ADDENDUM NUMBER 01 TO THE BID DOCUMENTS

BID DOCUMENT: 17/18 MB7
121 -35617 - Organic Farm Classrooms
College of Marin – Indian Valley Campus

Addendum Date: 20 February 2018

PROJECT NO: 1102-0005 DATE: 11-17-2017

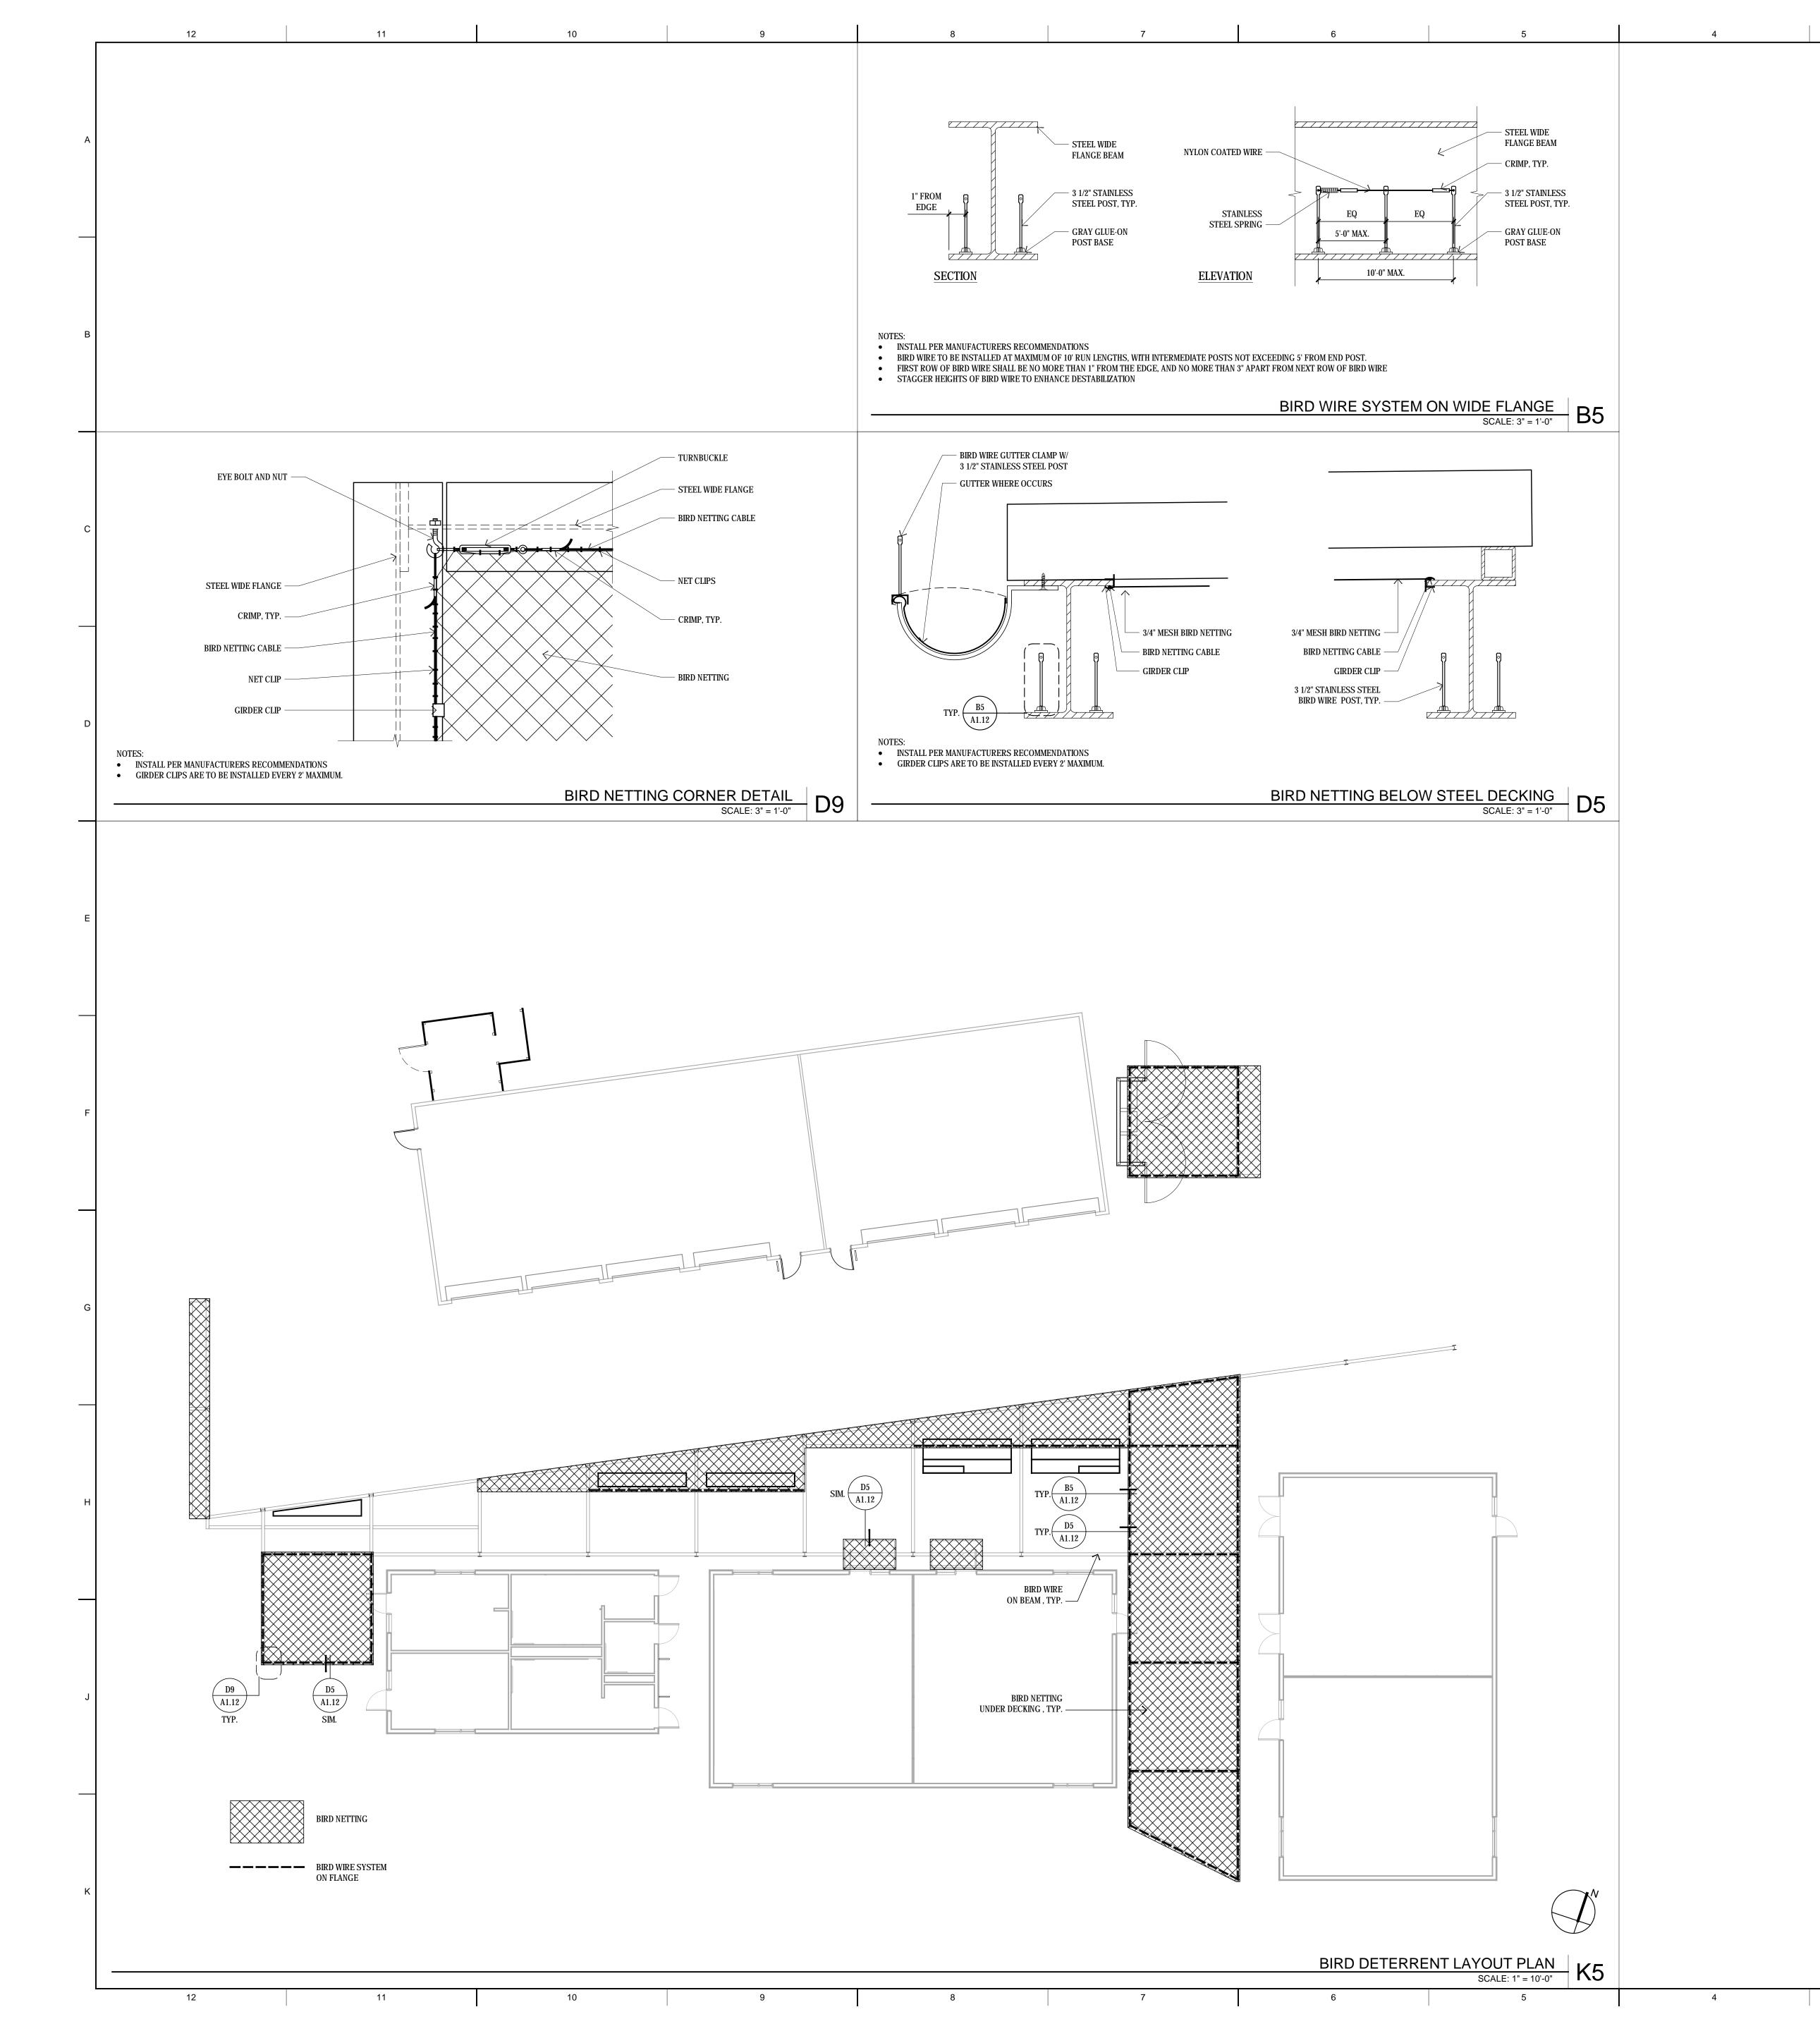
A1.00 Overall Site Plan (Replacement sheet)

Updated area of Scope of Work, existing Greenhouse, Shade Structure, Sea Crate and fencing to remain.

SITE DETAILS

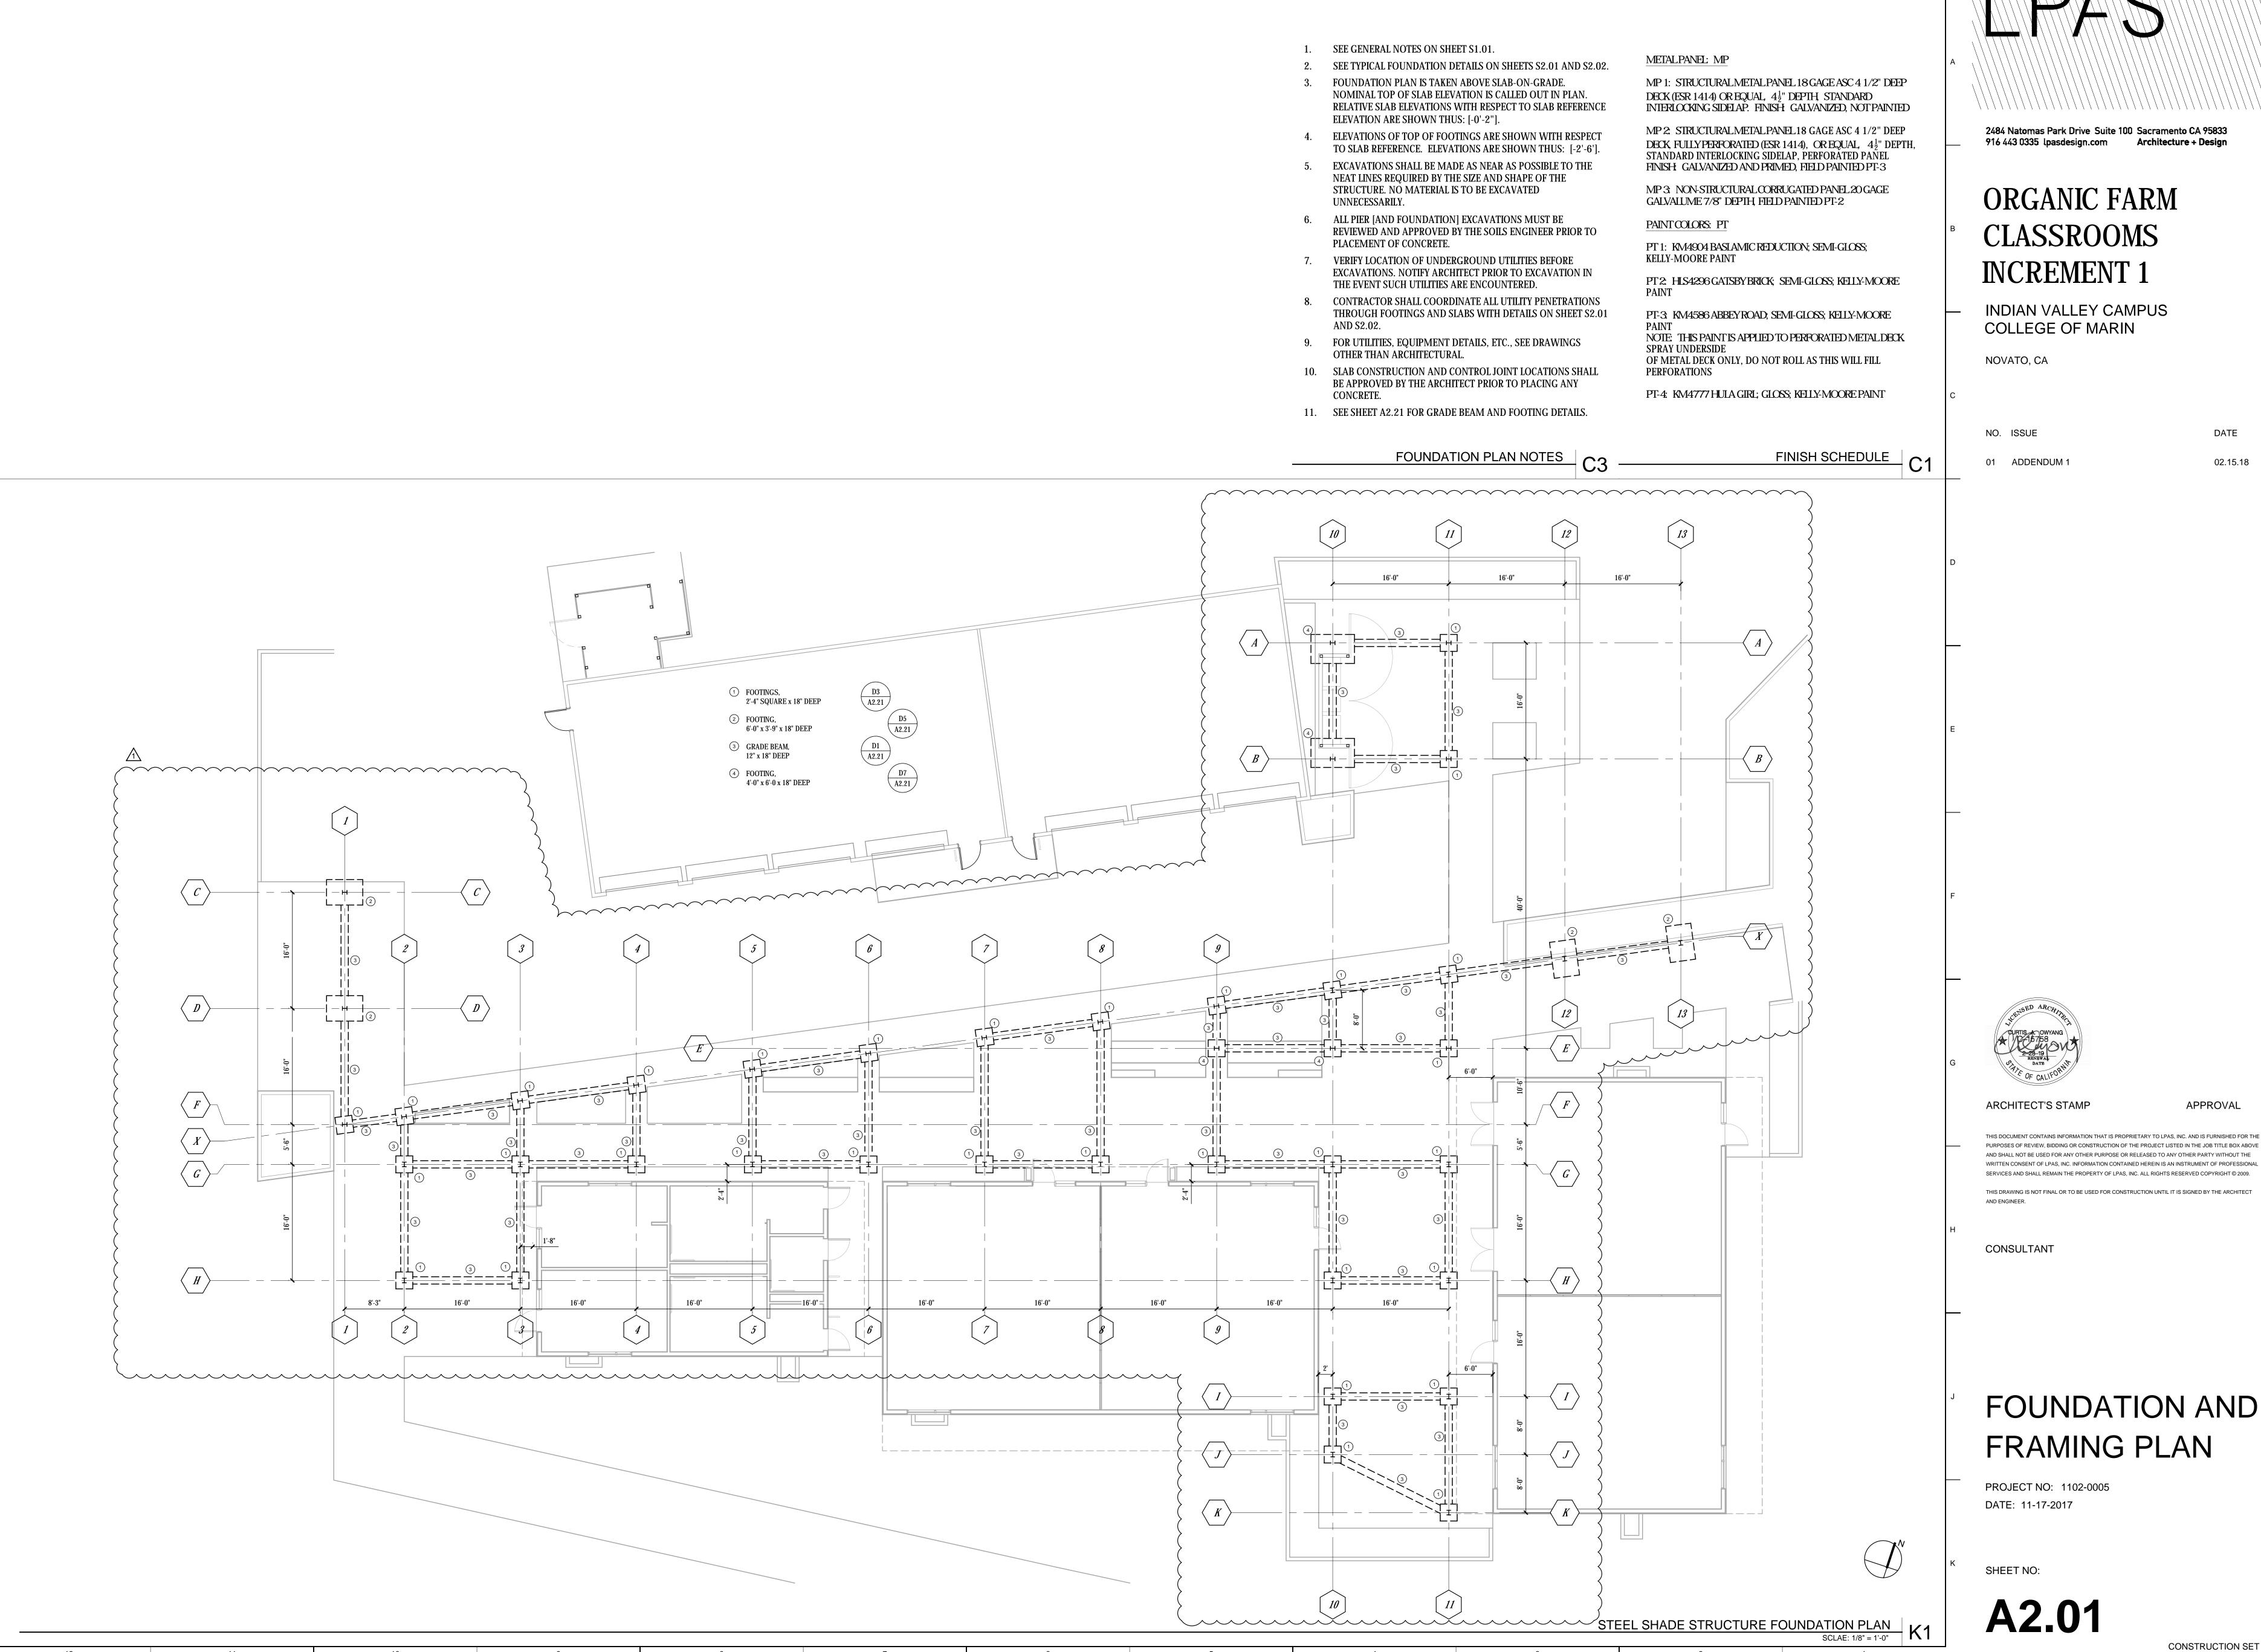
A1.12 Site Details (New Sheet)

- Added fence, bollard, and bird protection details.
- A2.01 Foundation and Framing Plan (Replacement Sheet)
 - Removed roof framing detail references.

IRRIGATION PLAN

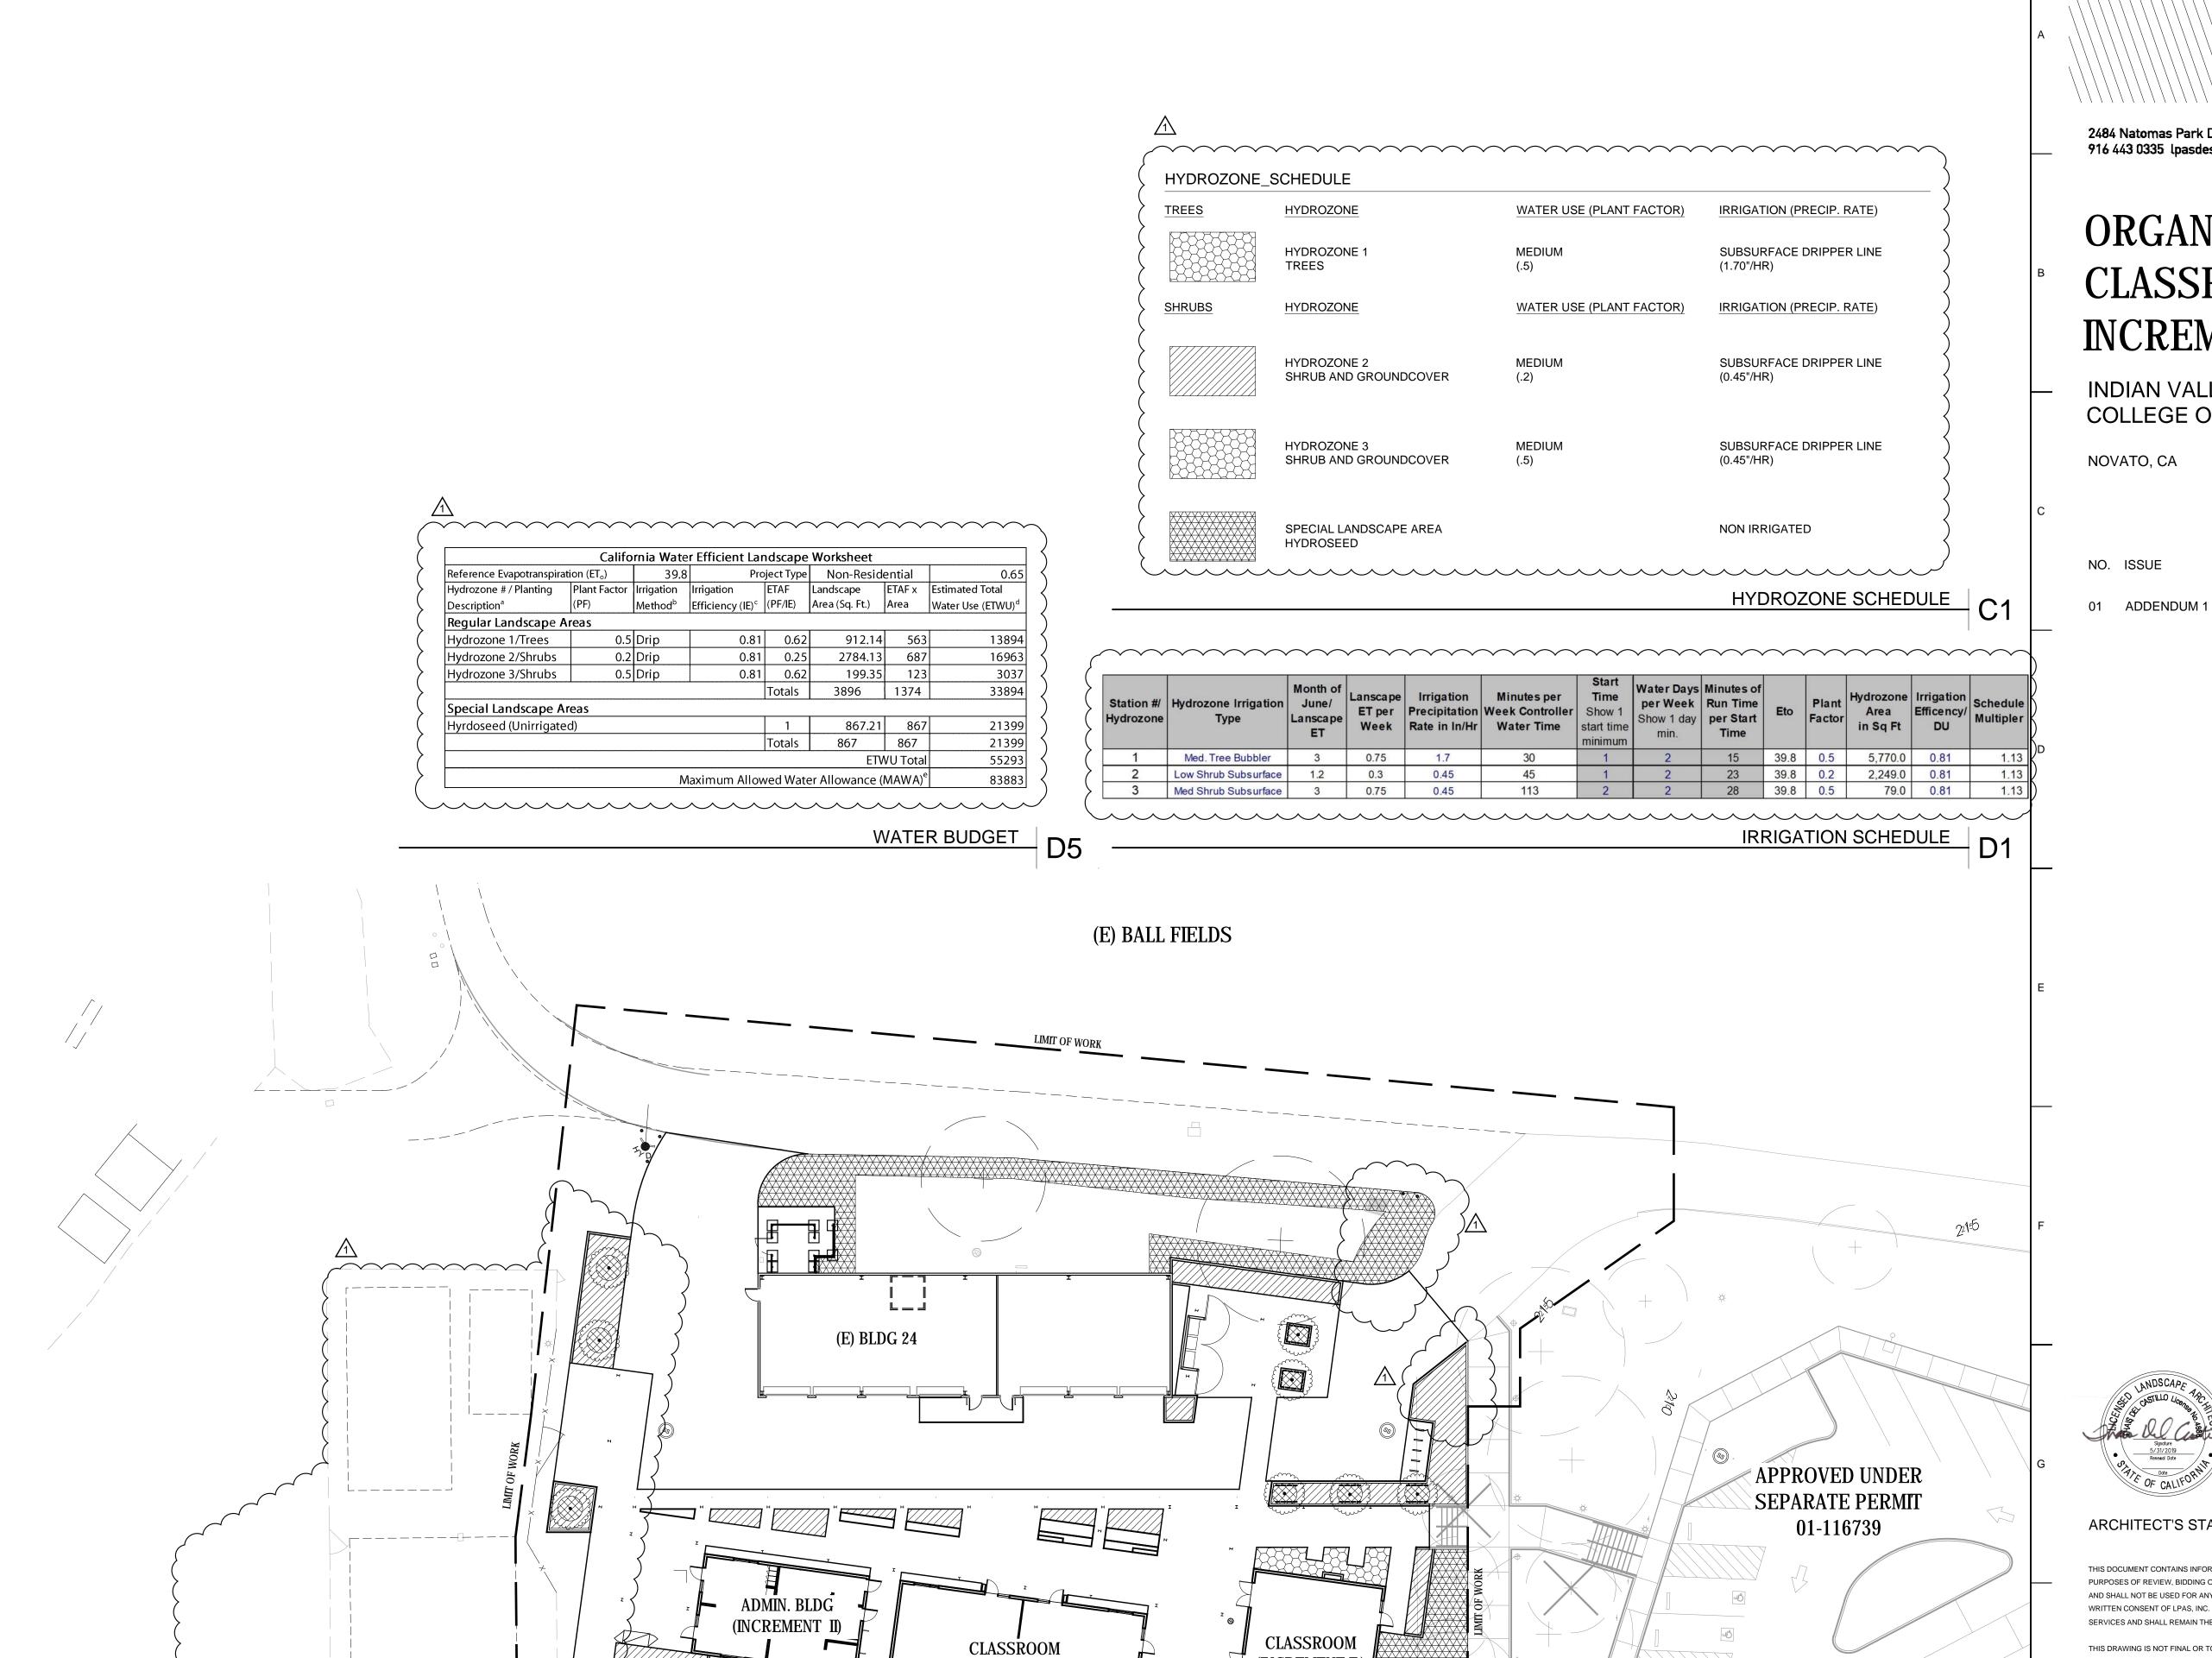
L2.00 Irrigation Plan (Replacement sheet)

- Updated area of Scope of Work, existing Greenhouse, Shade Structure, Sea Crate and fencing to remain.
- Entry drive revised
